TRANSMITTAL FOR INSPECTION SERVICE BULLETIN REVISION

SERVICE BULLETIN No.ASB.32-A189

TITLE: LANDING GEAR - MAIN LANDING GEAR SIDESTAY - INSPECTION OF THE
OUTER LINK (LH AND RH) FOR CRACKS AND DIMENSIONAL CHECKS.

REVISION: 2

INSPECTION OF MLG SIDESTAY OUTER LINK DRAWING 2.

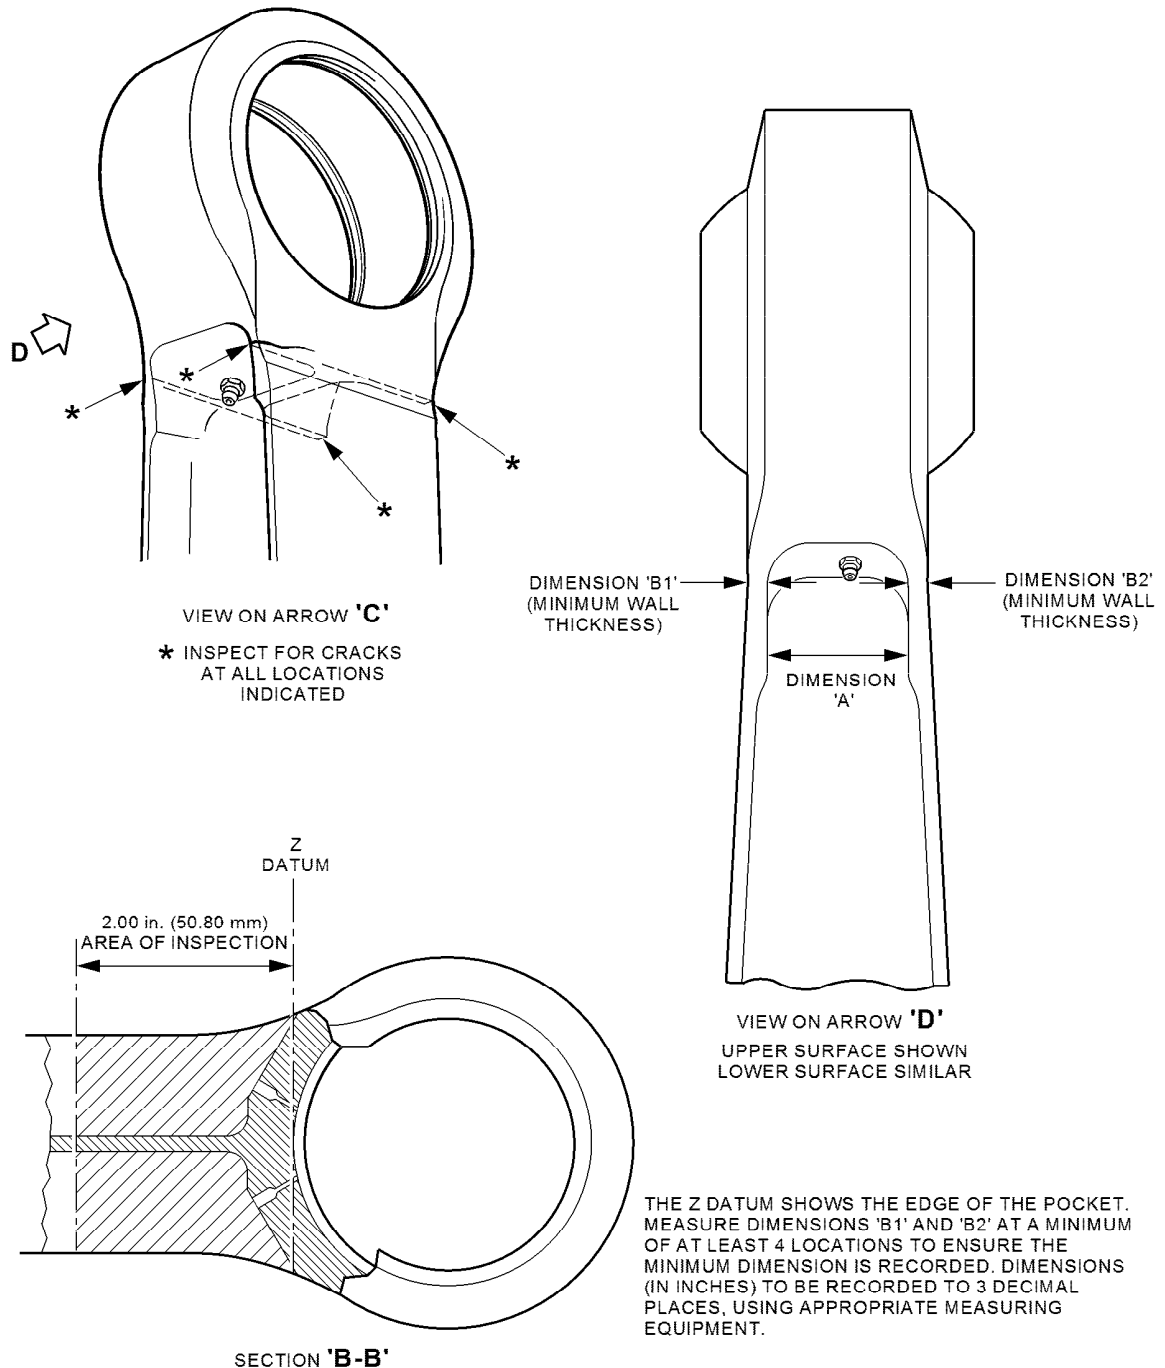
- (1) Refer to Drawing 2. Perform an inspection of the areas indicated in Drawing 2 (view on arrow 'C') as follows:
- (a) Carry out a Detailed Visual Inspection in accordance with SLS SB 146-32-179 (copy attached). In the event that a crack is detected, record the findings in Appendix 1 and return to BAE Systems Air Prestwick.
- or
- (b) Carry out a fluorescent dye penetrant (FDP) inspection in accordance with Messier-Dowty SB 146-32-147 Appendix A (copy attached). Once the FDP inspection has been accomplished, reinstate the Abrasion Resistant paint in accordance with BAE Systems Air Prestwick SB 53-217-61122A, 53-223-60809G, 53-227-60877A, 53-232-60809H or 53-248-61147A, as appropriate. In the event that a crack is detected, record the findings in Appendix 1 and return to BAE Systems Air Prestwick.

(b) Refer to Drawing 2. Measure the dimensions 'B1' and 'B2' in the area of inspection shown in Drawing 2. Measure each dimension at a minimum of at least 4 locations to ensure the minimum dimension is recorded.

MLG SIDESTAY OUTER LINK DIMENSIONAL ASSESSMENT DRAWING 3.

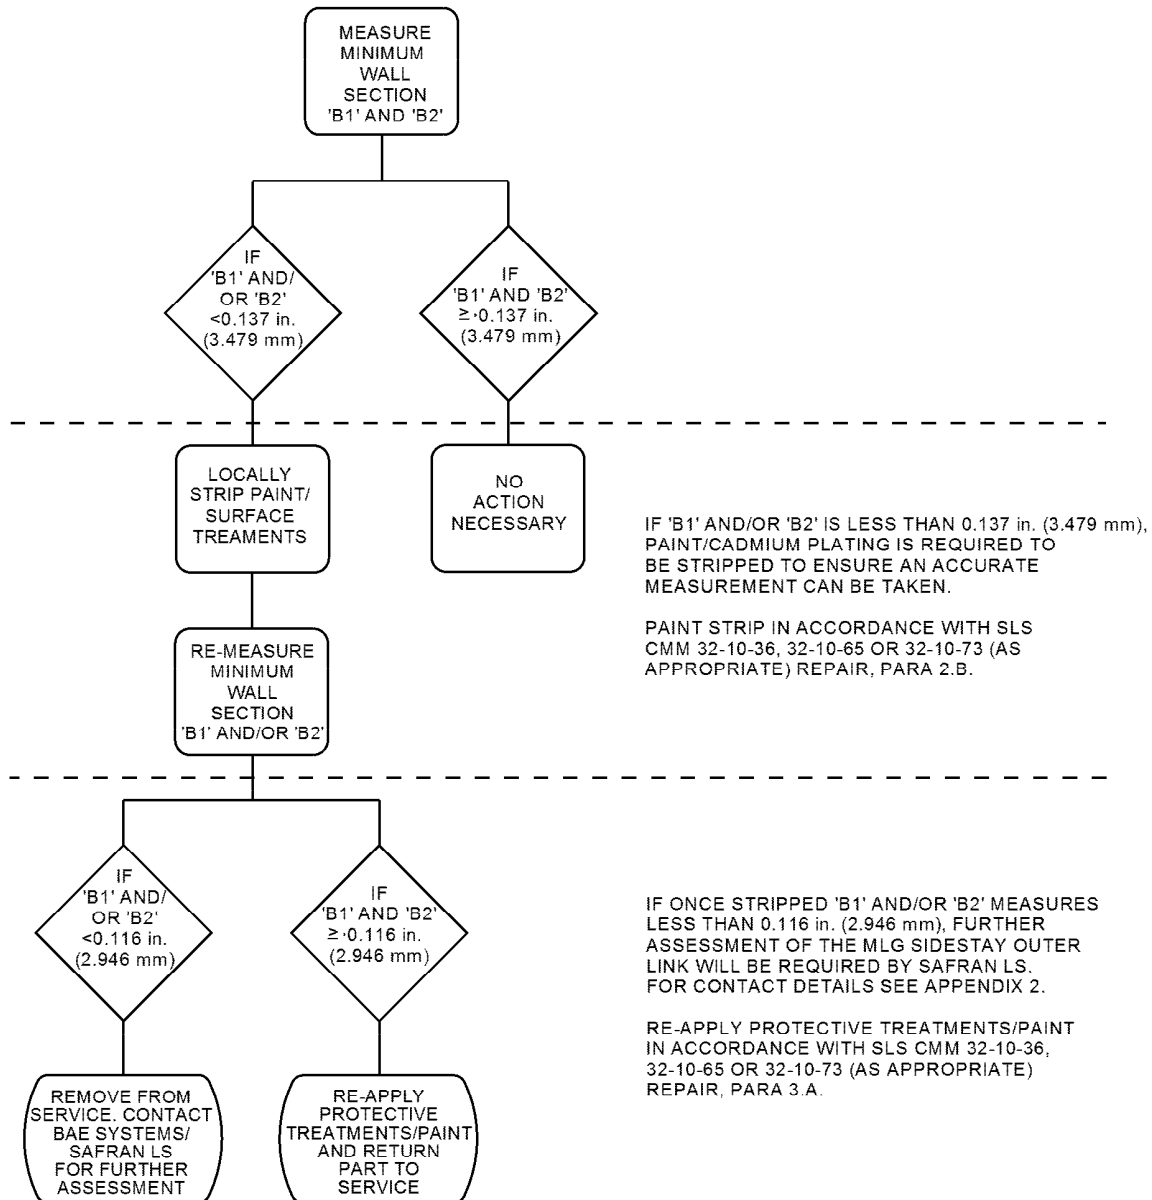
(c) Determine the status of the MLG sidestay outer link in accordance with the dimensional assessment flowchart in Drawing 3. Record in accordance Appendix 2 of ASB 32-A189.

Figure 2 - Location of Inspection

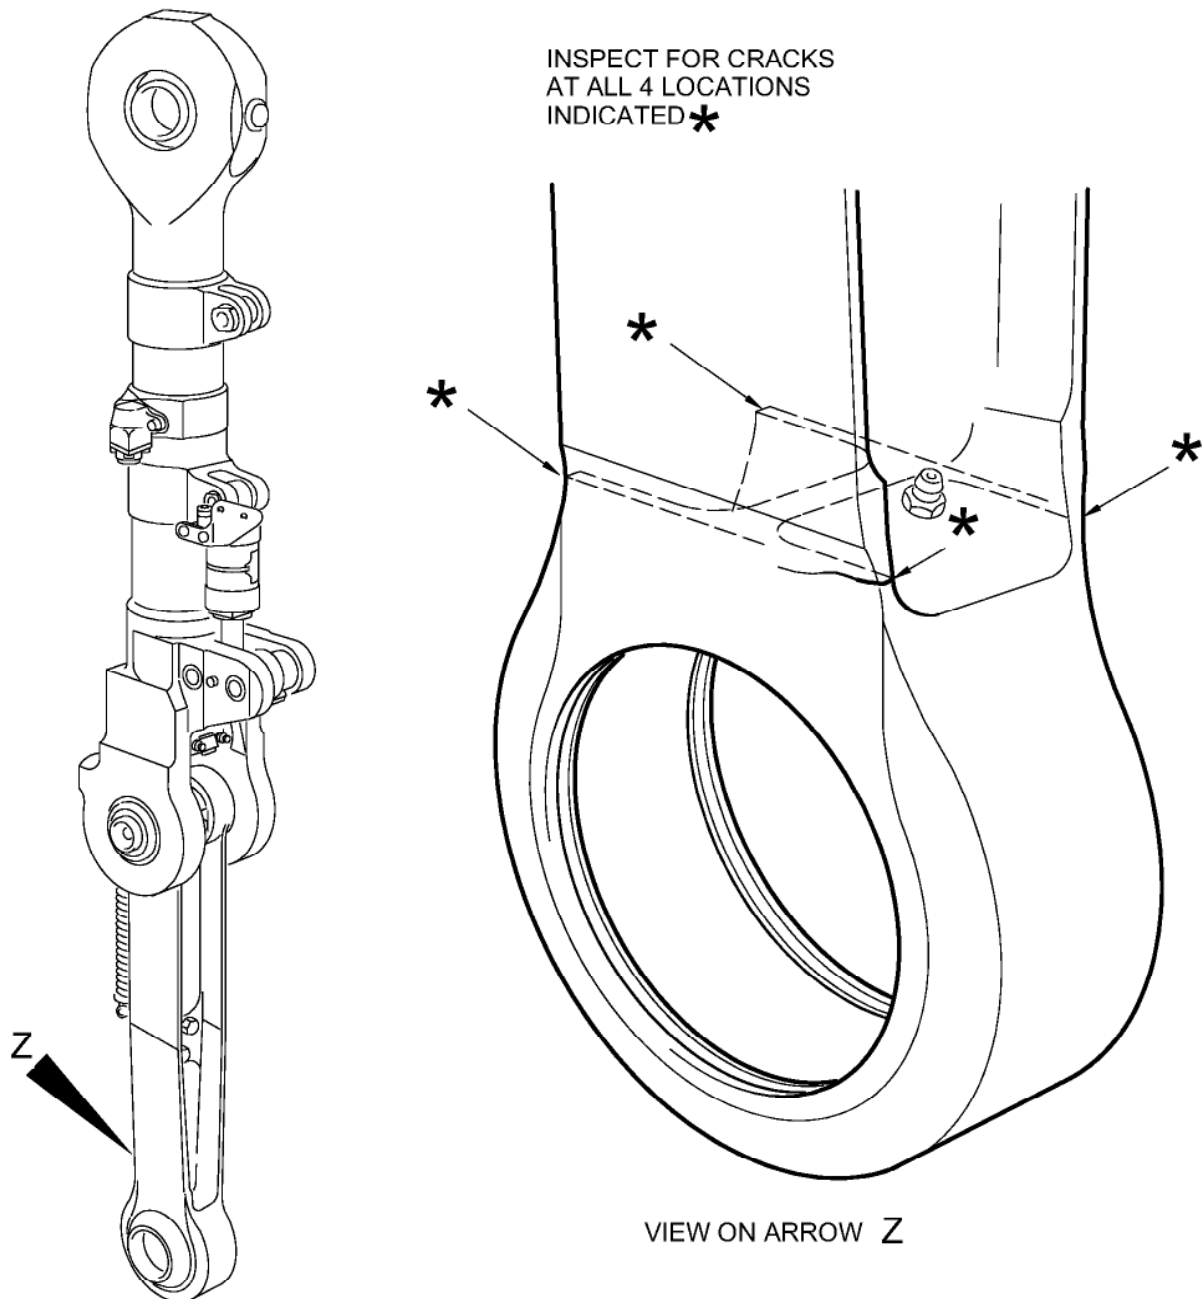
- 3.1. Following chemical and Scotchbrite local removal of paint and cadmium, thoroughly pre-clean the areas shown in Figure 2 using cold hydrocarbon or chlorinated hydrocarbon cleaning fluid.
- 3.2. Visually inspect the test areas to ensure a suitably smooth surface finish for high sensitivity fluorescent penetrant inspection and freedom from grease, corrosion, debris, metal smearing or mechanical damage which could interfere with the inspection.
- 3.3. Carefully apply thixotropic penetrant to the test area by brush and allow a contact time of 25 minutes. Use only enough penetrant for the area being inspected to avoid over application.
- 3.4. Wipe off surplus penetrant with clean dry cloths or tissues.

- (1) To inspect the outer link (Refer to CMM 32-10-36, 32-10-65, 32-10-73 and Figures 1 and 2 of this Service Bulletin)
- (2) Clean the outer link (4-150 or 4-160, CMM 32-10-36) or (4-150 or 4-160, CMM 32-10-65) or (4-150 or 4-160, CMM 32-10-73); refer to CLEANING in the applicable CMM.
- (3) Perform a detailed visual inspection (using 10x magnification) of the outer link (4-150 or 4-160, CMM 32-10-36) or (4-150 or 4-160, CMM 32-10-65) or (4-150 or 4-160, CMM 32-10-73) to check for any signs of cracks, with specific focus on the four areas defined in Figure 2.
- (4) If there is any indication of cracking, remove the outer link (4-150 or 4-160, CMM 32-10-36) or (4-150 or 4-160, CMM 32-10-65) or (4-150 or 4-160, CMM 32-10-73) and contact Safran Landing Systems for further advice.
